Hello Rahul,

A few things need attention in your schematic, setup, and simulation.

Transistor widths:

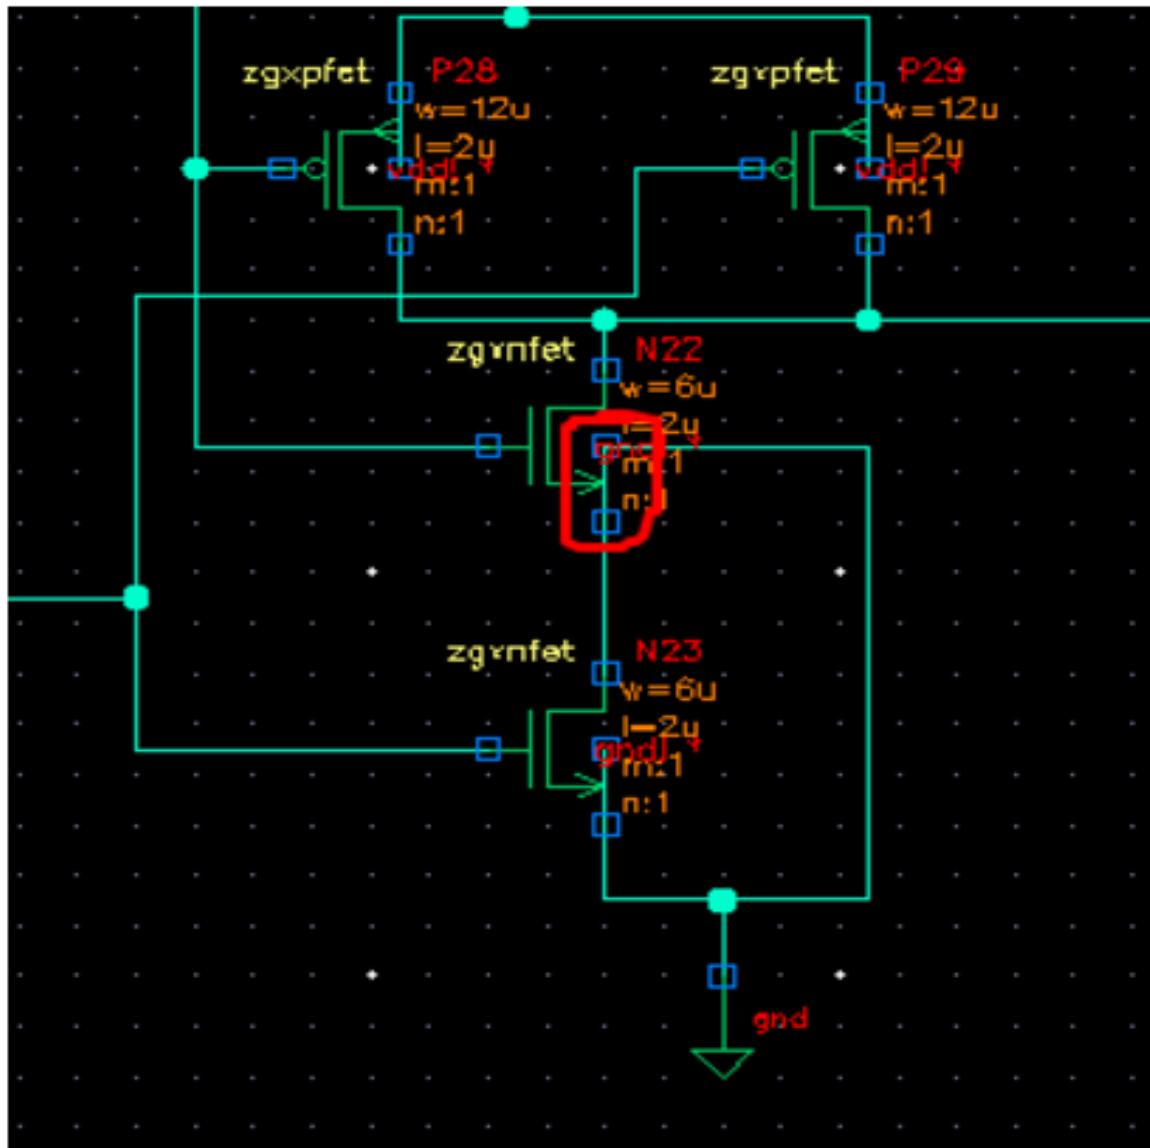
Main switching devices (P0 and N0 in your schematic): Make them as wide as appropriate to have a small voltage drop across them, when they are turned on and carry the inductor current. Make sure you check this with a reasonable value for the inductor current.

The current dimensioning (12.8/3 and 9/4) seems quite small.

Transistor widths in the inverter chain: work backwards from the main switching devices: Last inverter stage: approximately chose $w_{last} = w_{main}/6$ for both pfet and nfet. Make the pfet somewhat wider than the nfet.

From stage to stage, backwards through the inverter chain, the width can be reduced by a factor of about 3 to 4.
